Comment Response Letter

Project Name: Hendricks Commons

Project Log Number: DSRFY2023-0009

1 MECHANICAL SCREENING EXHIBIT
1/8" = 1'-0"

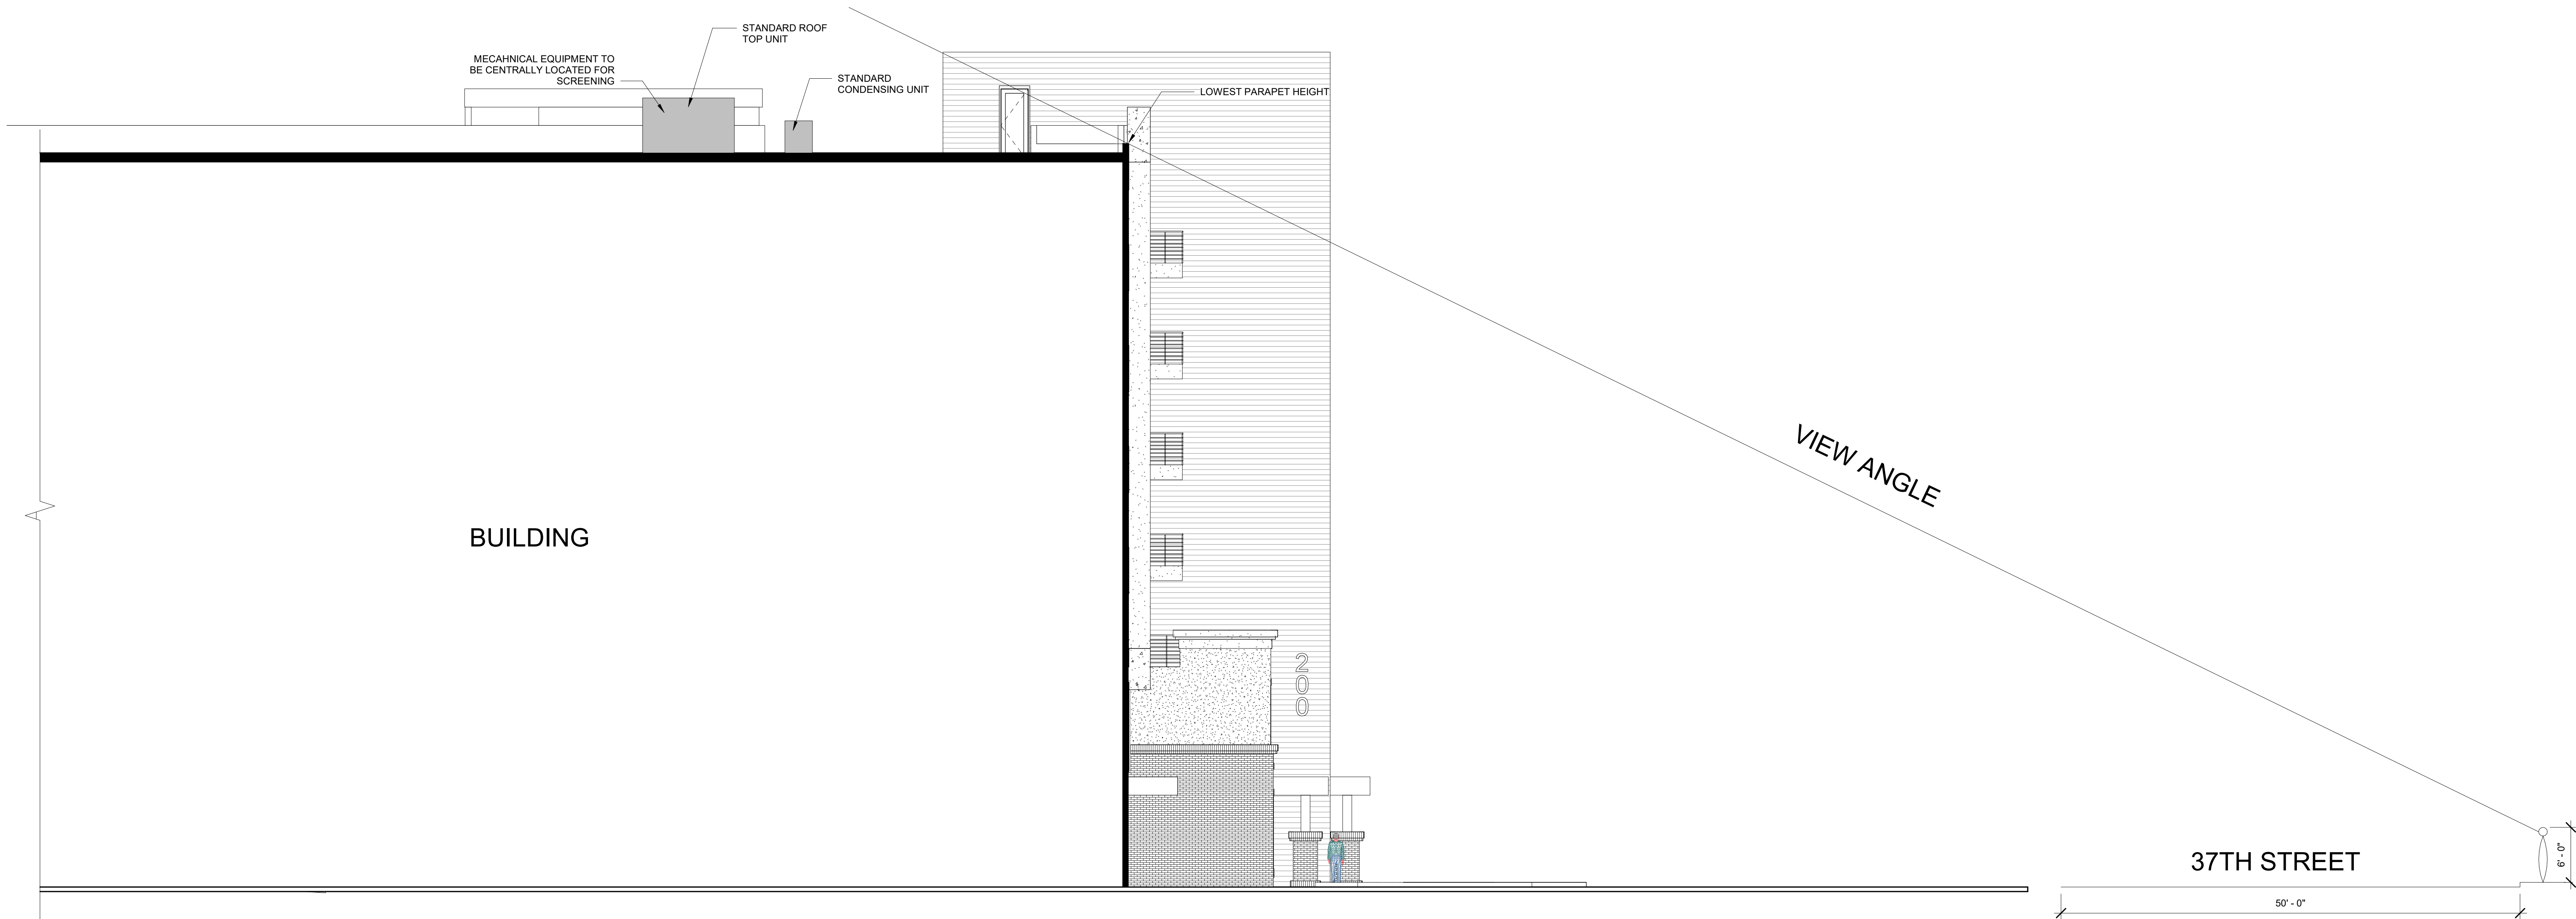
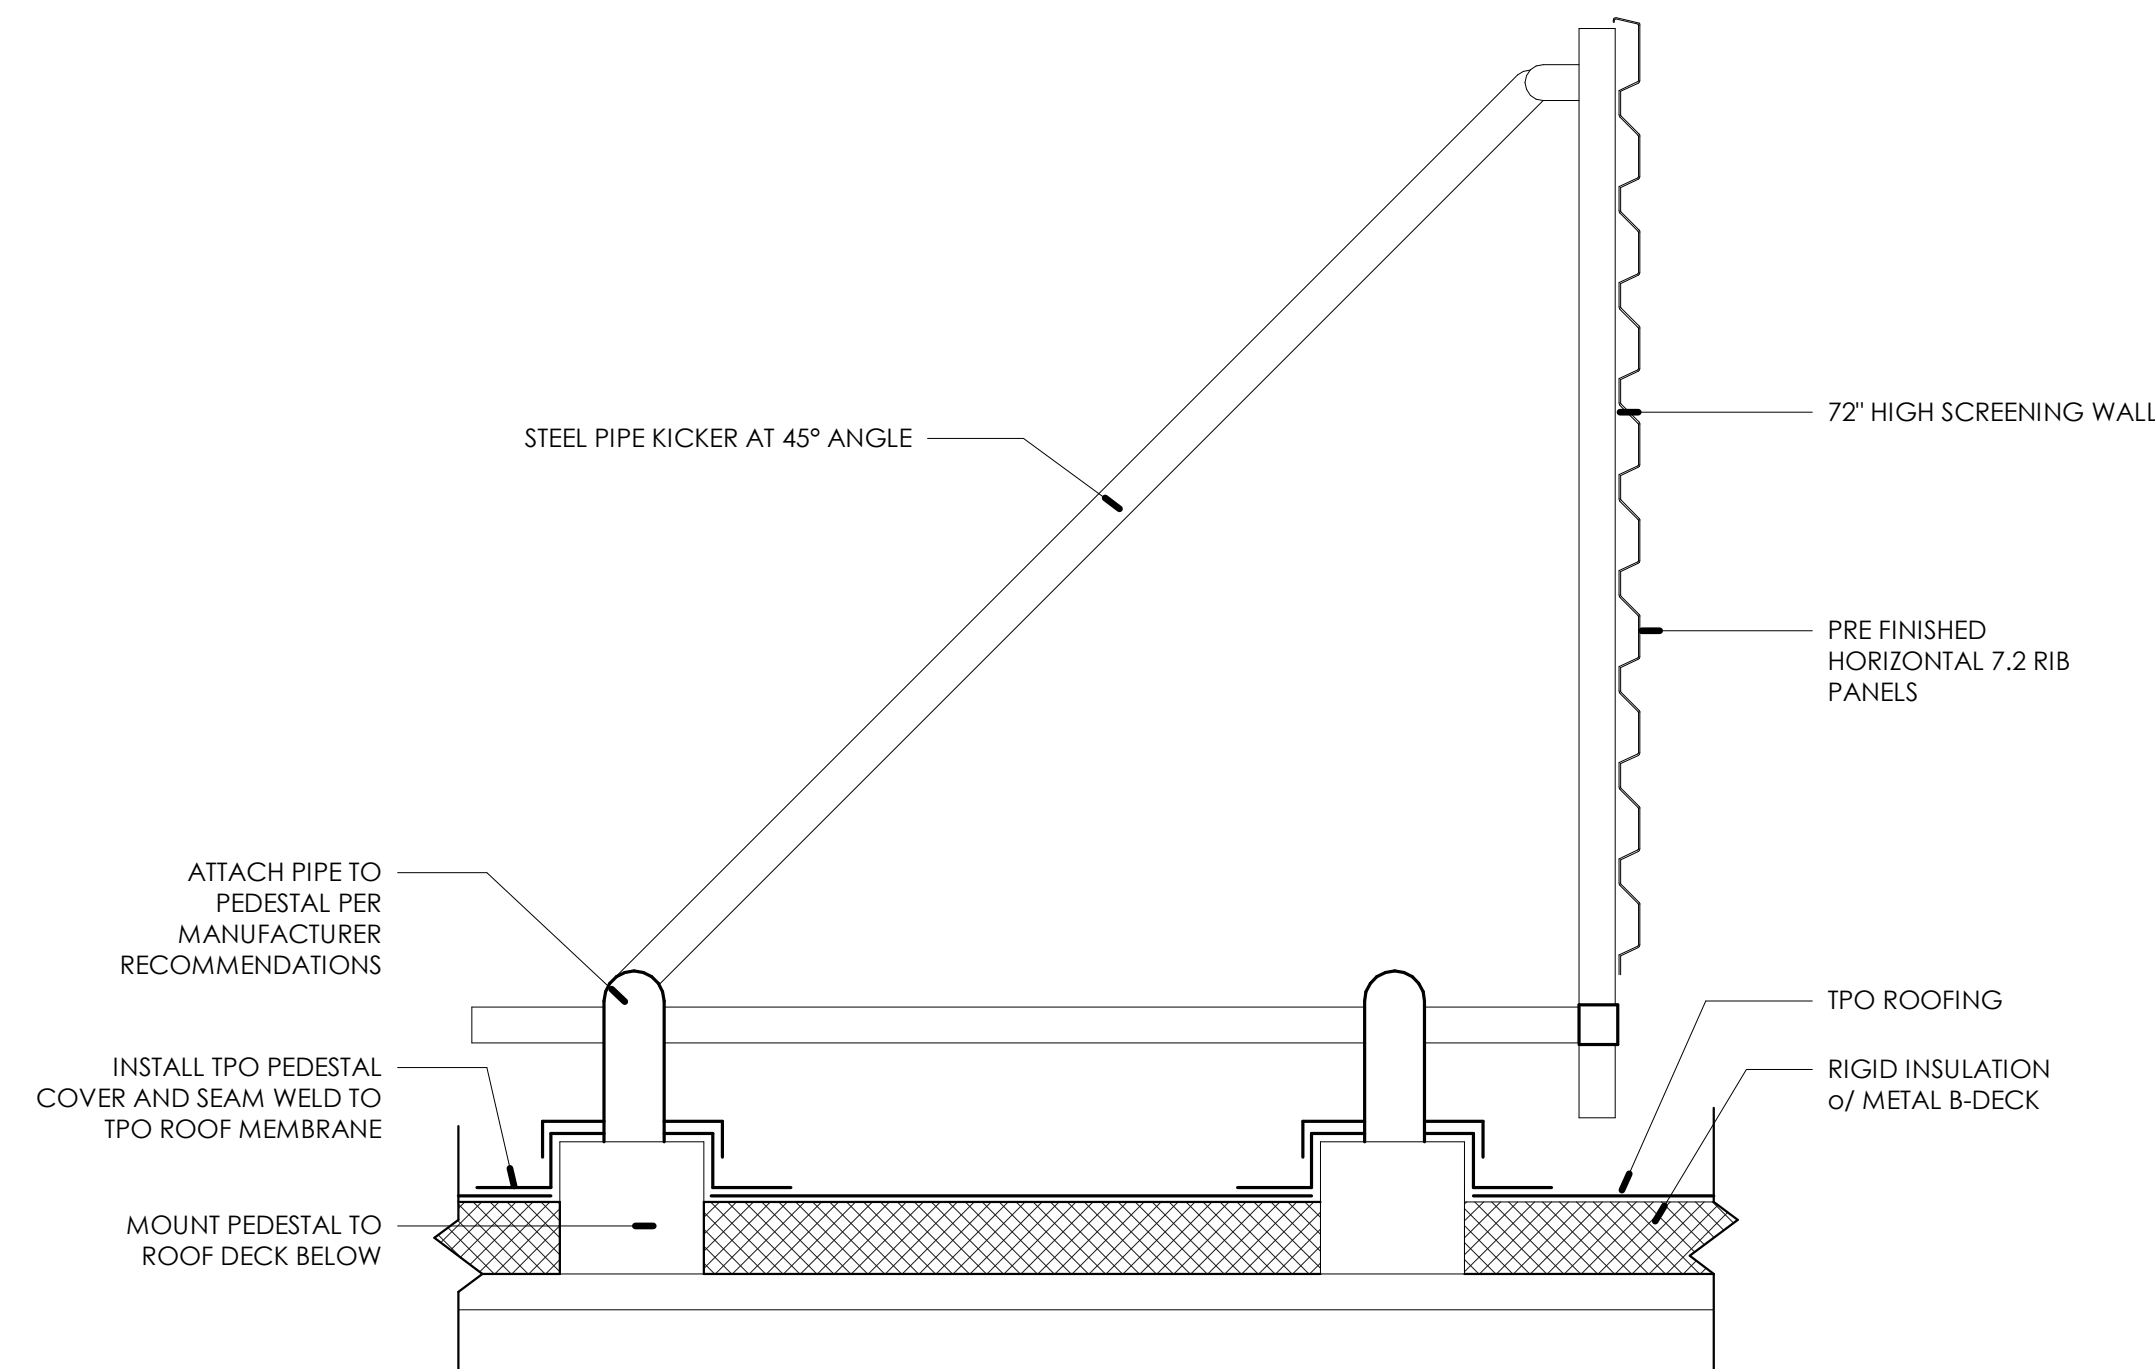
1. Mechanical equipment location and screening has not been addressed.
Response: Mechanical equipment is intended to be on the roof and screened by the building parapets. Please see Mechanical Screening Exhibit Sheet A311.

13. Model rooftop mechanical and provide for screening from public view.

Response: Mechanical screening is intended to be screened by building parapets from the ground level, please refer to mechanical screening exhibit sheet A311. In addition to being screened from the ground level by parapets and view angles, mechanical screens will be added around mechanical gardens to screen them from the rooftop amenities, as well as surrounding buildings of similar height. Please see building renderings for elevated views.
